Submission regarding RESOURCE CONSENT HEARING REQ.596300 – AUPOURI AQUIFER WATER USER GROUP – 24 RESOURCE CONSENT APPLICATIONS FOR GROUNDWATER TAKES FROM THE AUPOURI AQUIFER FOR HORTICULTURAL IRRIGATION

Summary Position

Fig. 1: LA2015
 Schematic profile through the Aupouri Aquifer

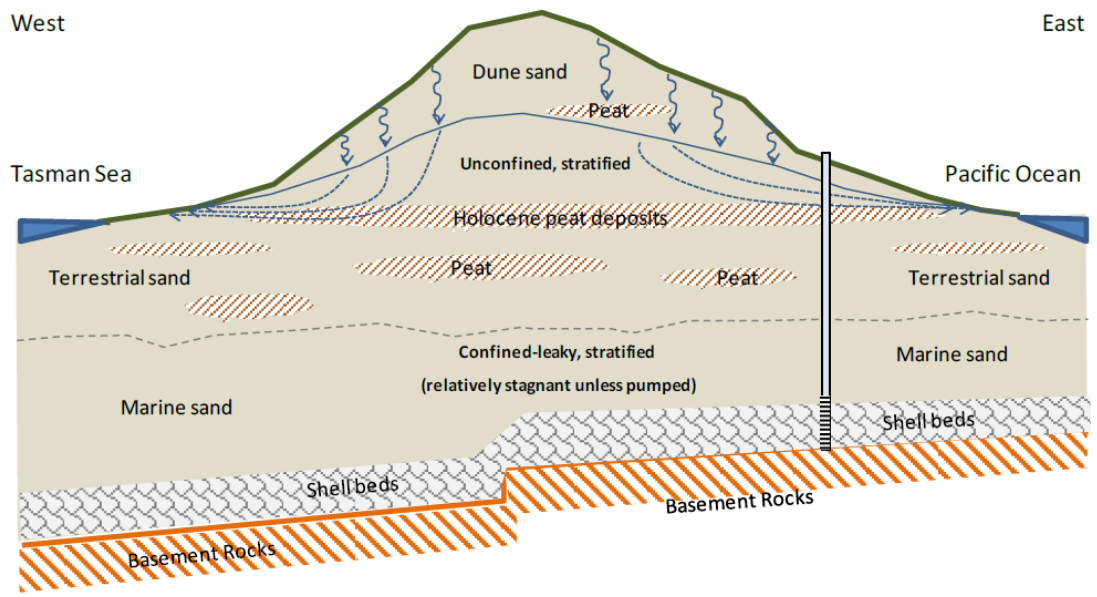
For reference, Figure 1 shows a highly schematic cross-section across the Aupouri peninsula from the LA2015 report. The stratigraphic succession consists of a lower marine unit of shell beds, sands and silts surmounted by an upper terrestrial sequence of dune sands, peats, clay layers, and diagenetic pans, sitting upon a basement rock surface that dips from east to west.

Fig. 2: LA2015
Basement
Elevation (m)

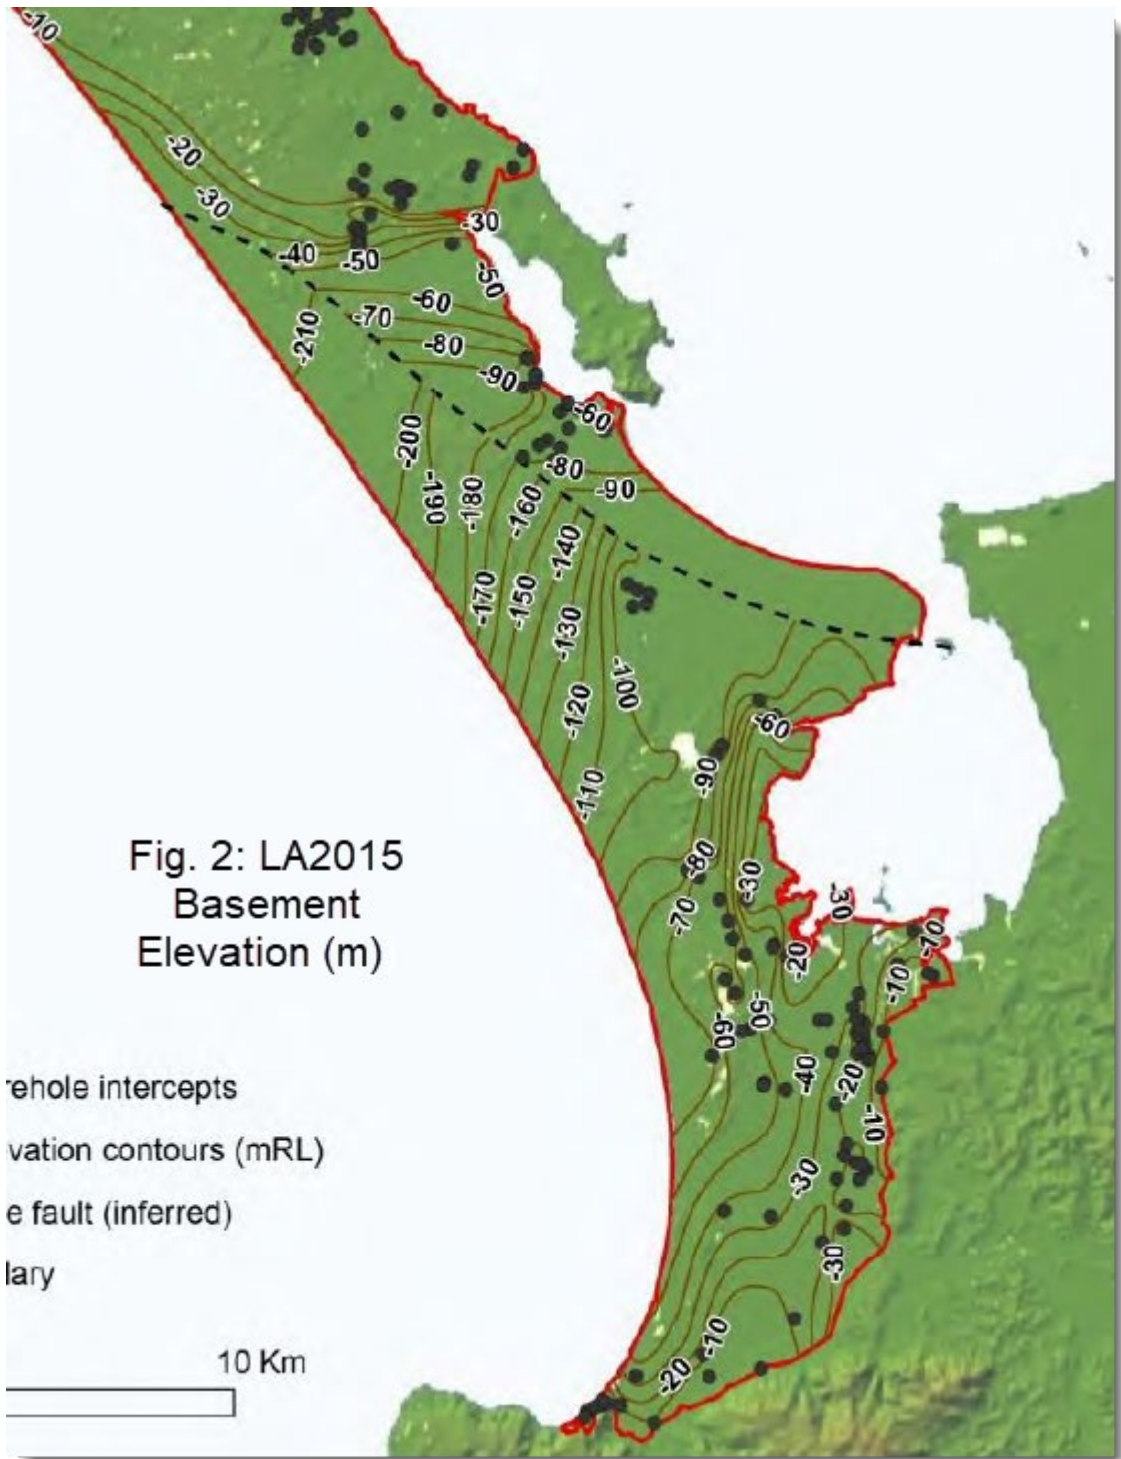
The LA2015 map is based on well data, partially constrained by limited seismic refraction and gravity data. Based on an inference from aeromagnetic data (Stagpoole et al., 2012), the LA2015 authors have included a faulted contact between the Mt Camel Terrane and the Caples Terrane running from The Bluff towards Karikari Peninsula, deepening the basement significantly towards the west.

The elevations in the maps differ very significantly (by up to 150 m).

In areas of close well coverage both maps show significant topographic relief on the basement (although the contours differ in detail). This is hardly surprising, as the outcropping Mt Camel volcanic rocks on the eastern side of Houhora show rugged topography. Looking across Houhora Harbour to Mt Camel you can appreciate that the basement rocks under the main part of the peninsula will also likely feature local buried hills and valleys, which will have a significant impact on local subsurface hydrology.

With respect to the LA2015 map, the overall western basement slope in the central part of the peninsula is probably consistent with refraction data from Hukatere (which I haven't seen), and is certainly consistent with the overall westerly tilting of Northland that occurred in the Miocene. However, I consider it unlikely that there is a large distinct fault scarp along the boundary between the Mt Camel and Caples terrane (LA2015), because the terrane collision would have occurred at least 23 million years ago and there would have been ample opportunity for a fault scarp to be degraded. However, there may be buried geomorphic features related to differences in basement rock types.

Fig.3: WWLA
Basement
Elevation (m)

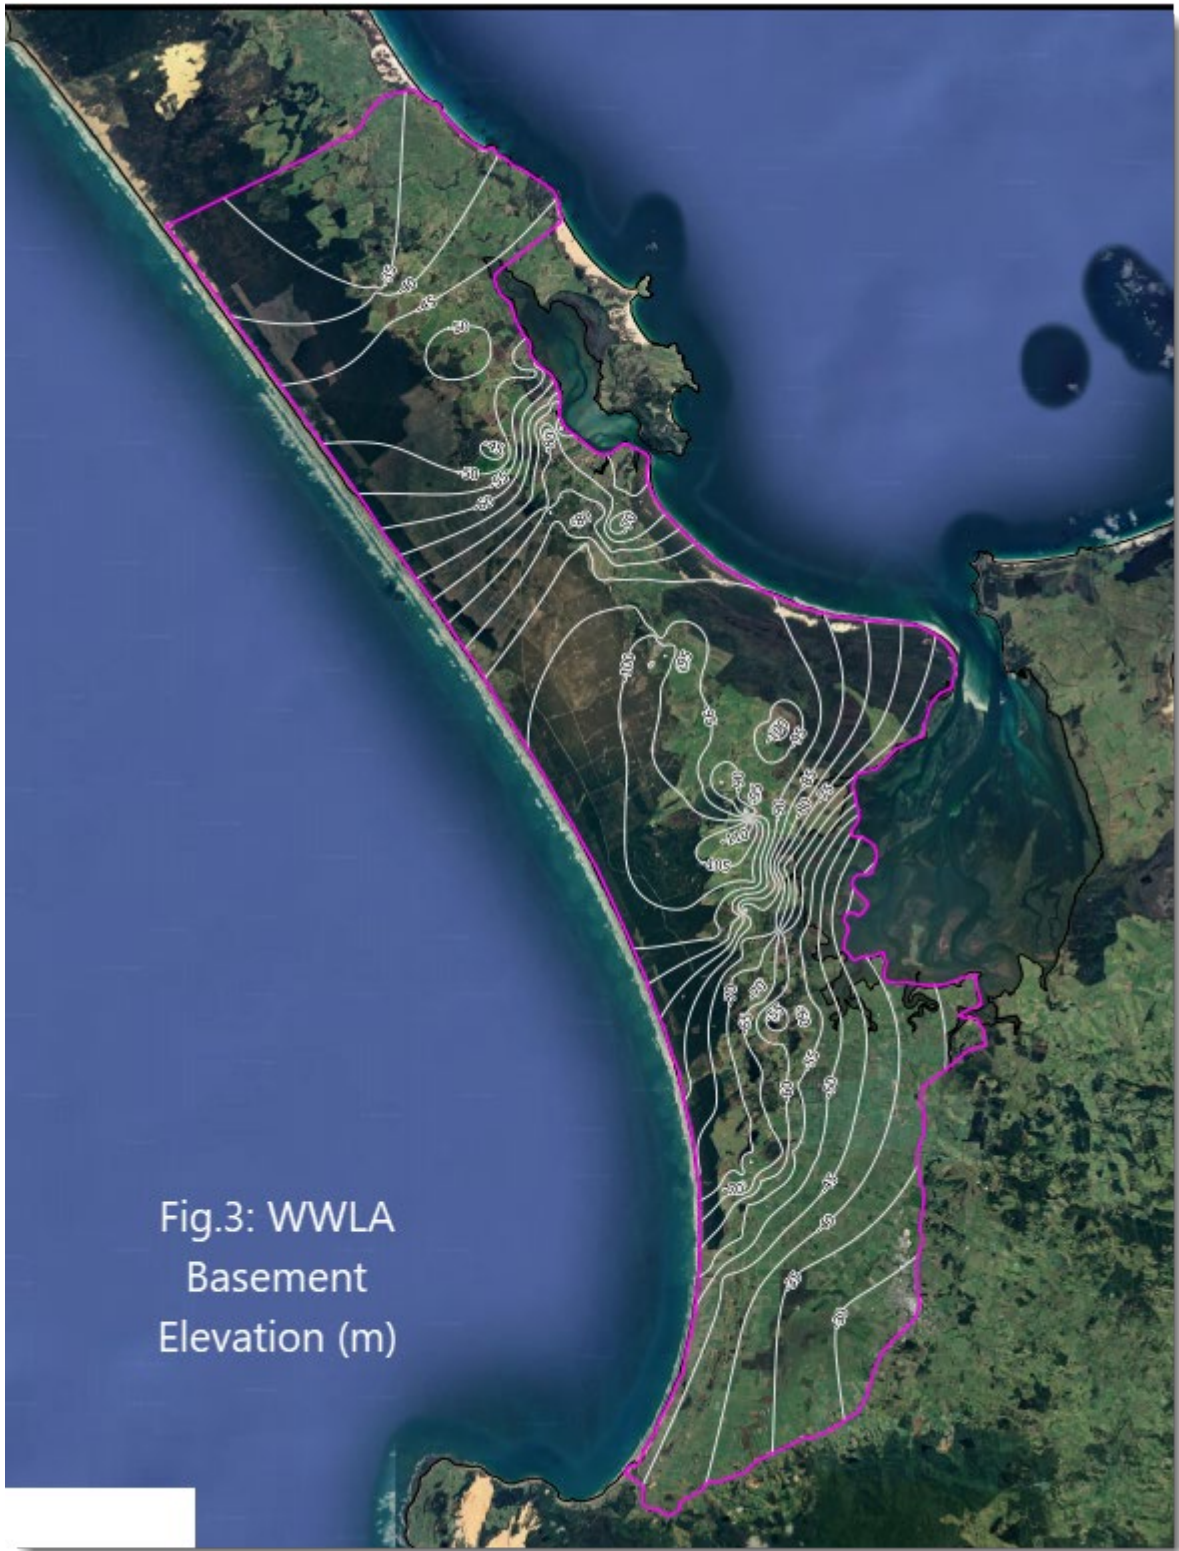
Conversely, the WWLA map appears to be based on naïve computer interpolation without regard to any informed geological hypotheses in areas where there is no well data. I note that in the oil industry naïve computer-generated maps are universally disallowed unless there is close well or geophysical control, because of their inherent unreliability.

Fig 4: WWLA Well Lithologies

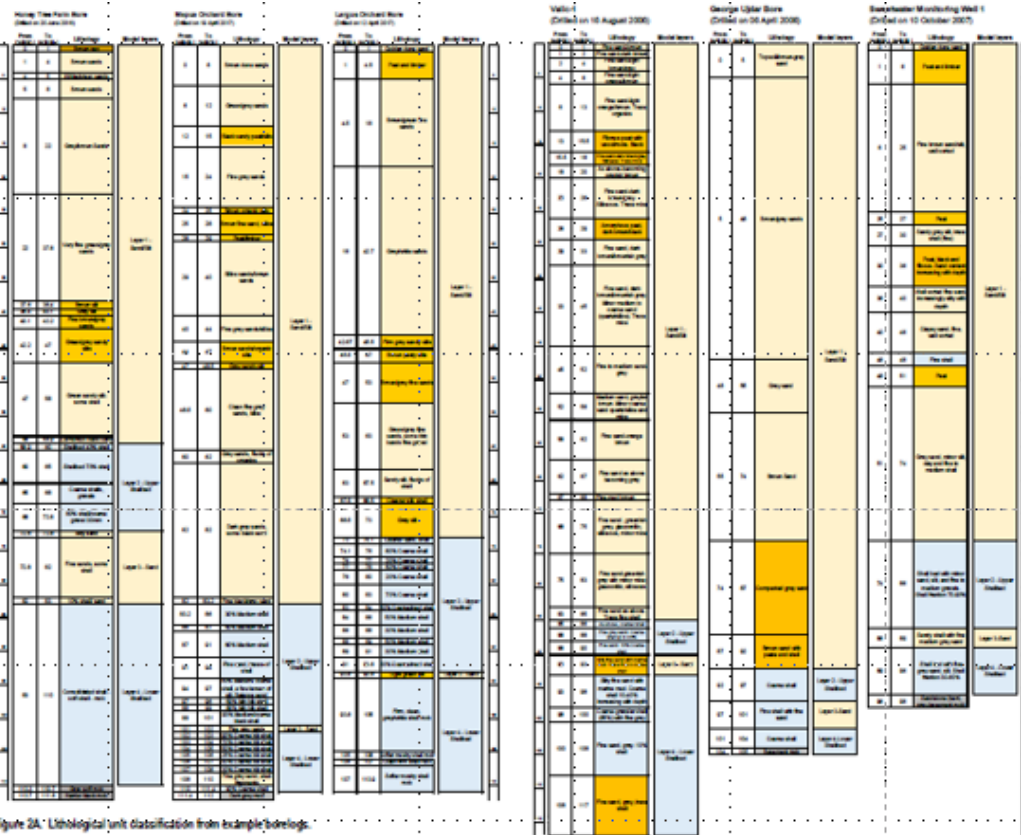
The lithological variation from well to well within the sediments of the aquifer is extreme (Figure 4), particularly for units that lie below the level of the widespread Holocene peat deposits that occur close to sea level. In consequence, the interpolation of physical properties to areas away from well control using kriging is almost certain to lead to unreliable models. The hydraulic conductivity of various units within the sequence varies by a factor of over 100. In the LA2015 and WWLA models the vertical anisotropy for lumped layers is estimated using PEST optimization of well pressure data..
